**In re: Application of Pennsylvania-American Water  
Company for Approval of the Right to Offer, Render,  
Furnish or Supply Water Service to the Public in an  
Additional Portion of Franklin Township, Adams  
County, Pennsylvania (Chambersburg Road)**

**Docket No. A-2022-3037221**

**TUS Data Request Set 1**

# Attachment A-2

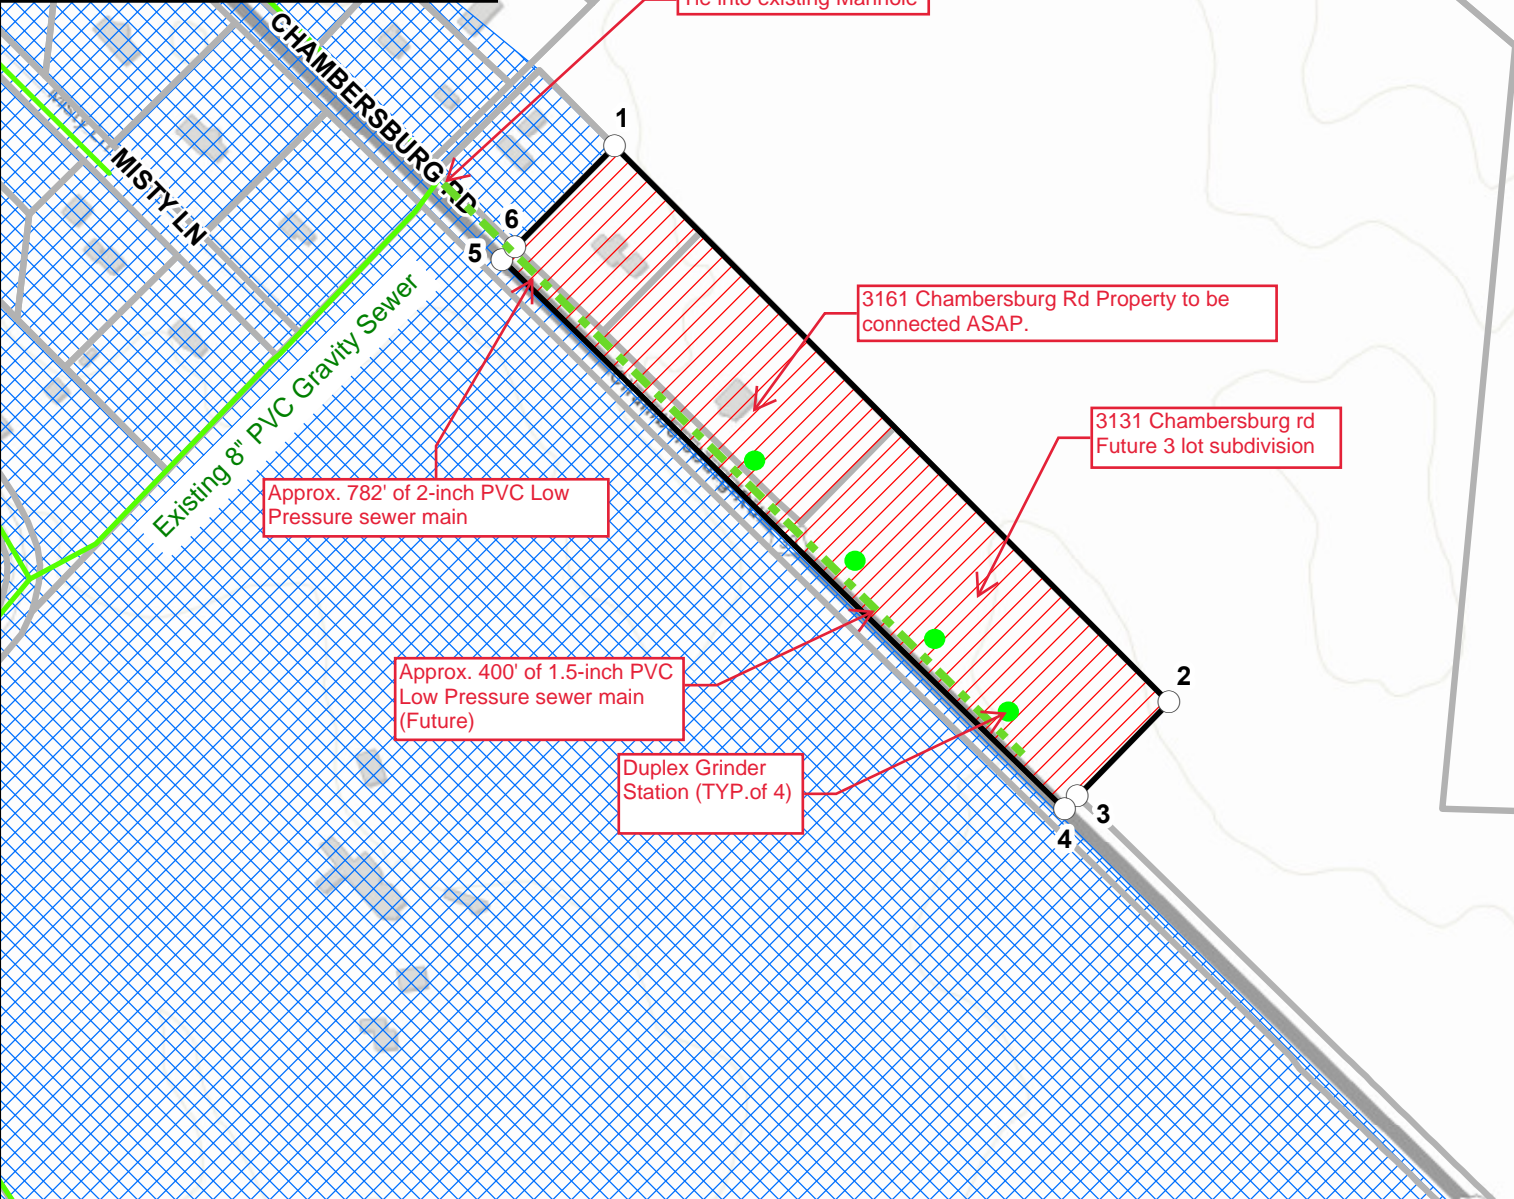
**A-2** The Service Territory Map does not identify the location or route of the proposed wastewater facilities. Please provide a copy of a map of suitable scale that identifies the planned location or route of the proposed wastewater collection facilities within the requested service territory.

**A-3.** Please quantify the diameter, material type, and type of main (i.e., force or gravity) of the existing main depicted on the Service Territory Map.

**Response:** Please see the revised map at **Attachment A-2**.

**Response:** Please see the revised map at **Attachment A-2**.

**Attachment A-8**

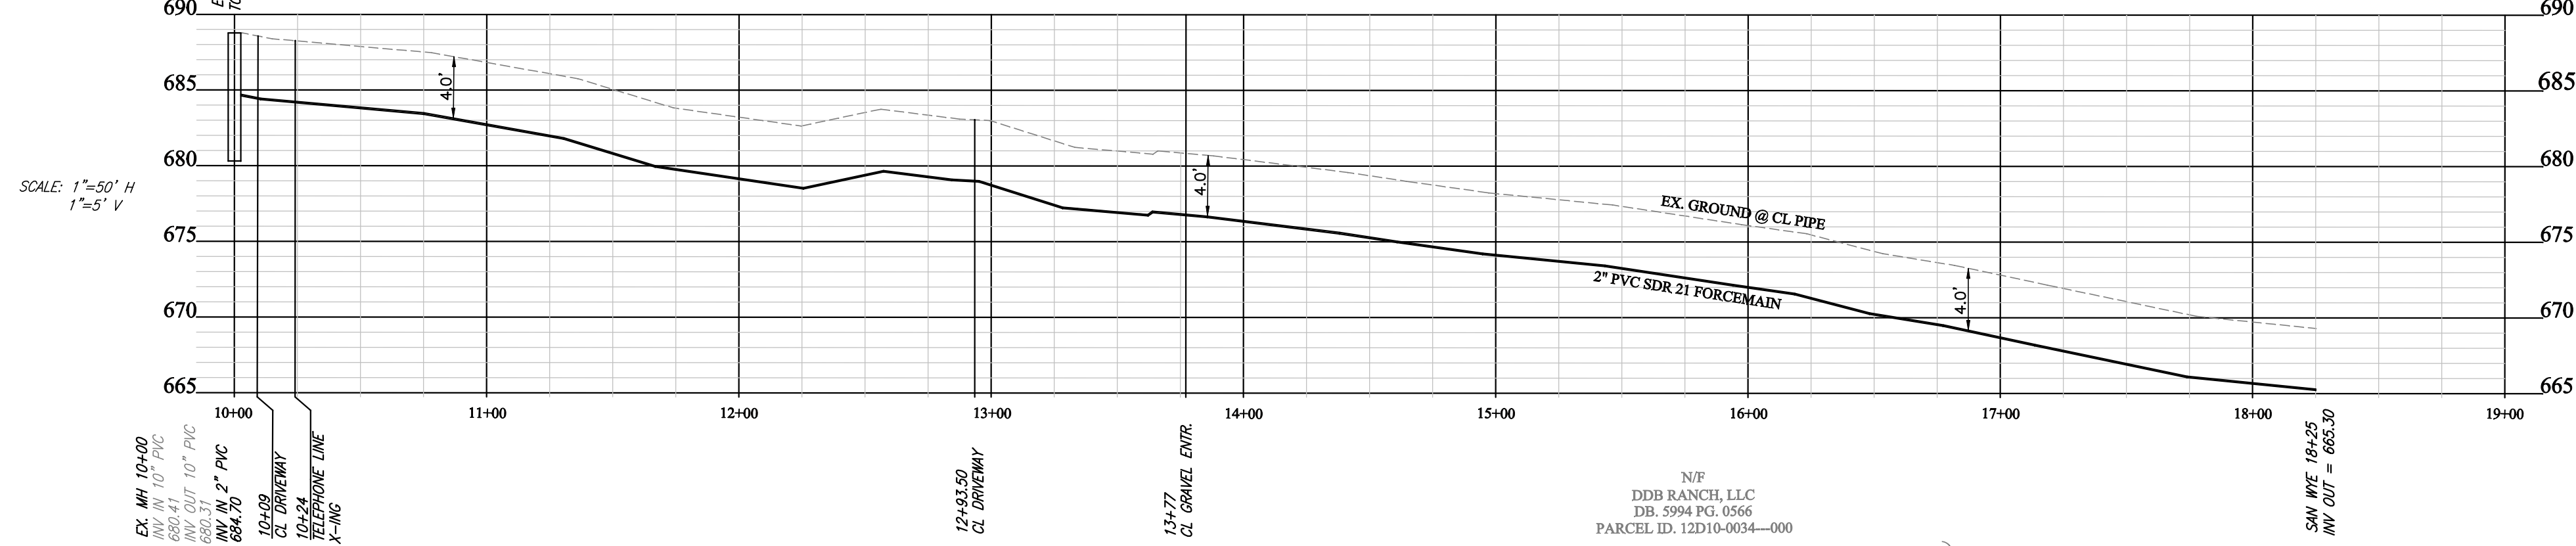
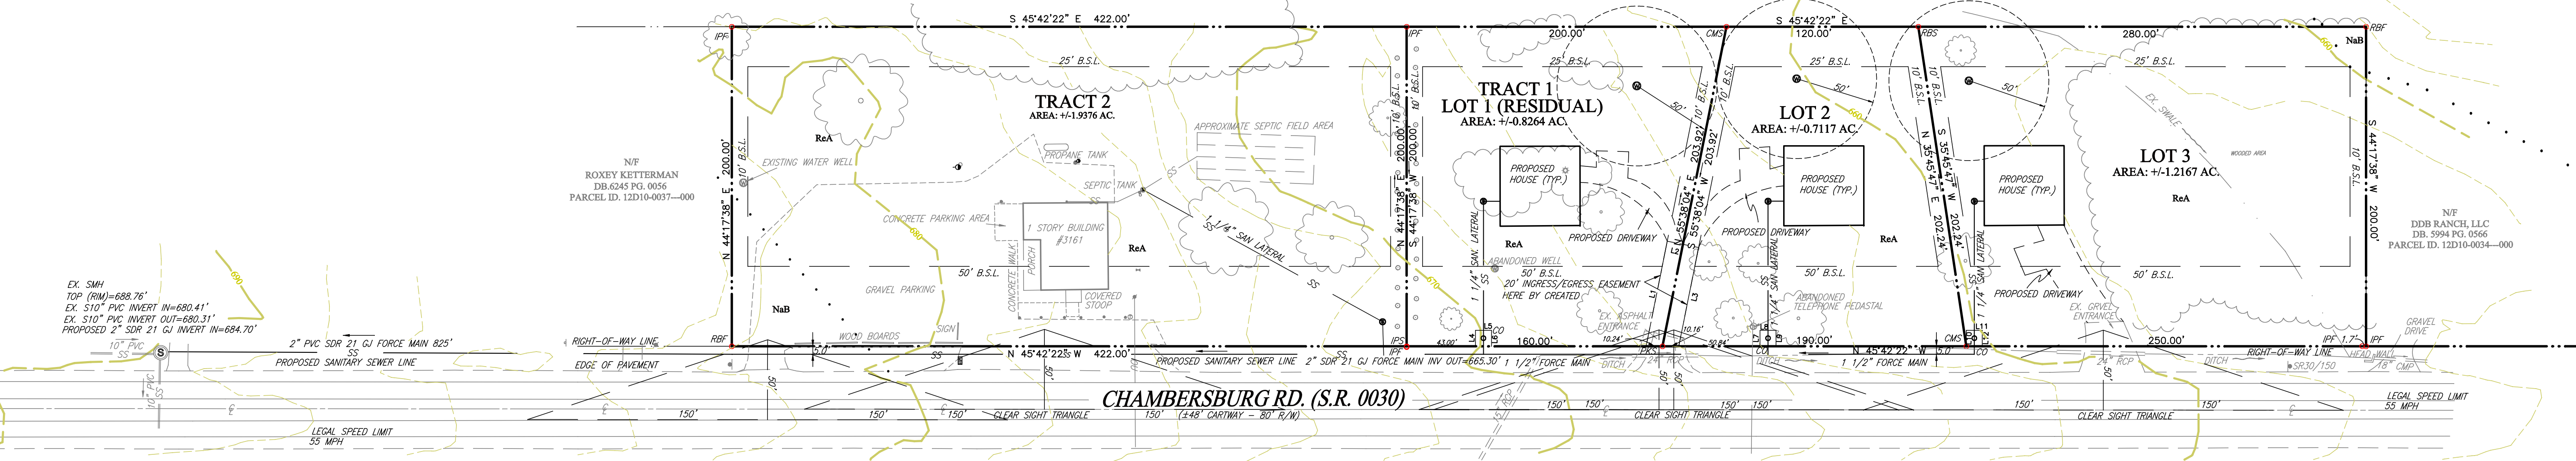
**A-8.** The Application's Exhibit C – Preliminary/Final Subdivision Plan, included a copy of a plan sheet (Plan Sheet) that is not legible and appears to have been overlaid on another document. Additionally, the Plan Sheet appears to be labelled as "Sheet 2 of 2". Please provide a complete and legible copy, in vector graphic format, of the development plan

**Response:** A full set of plans can be found at **Attachment A-8**.
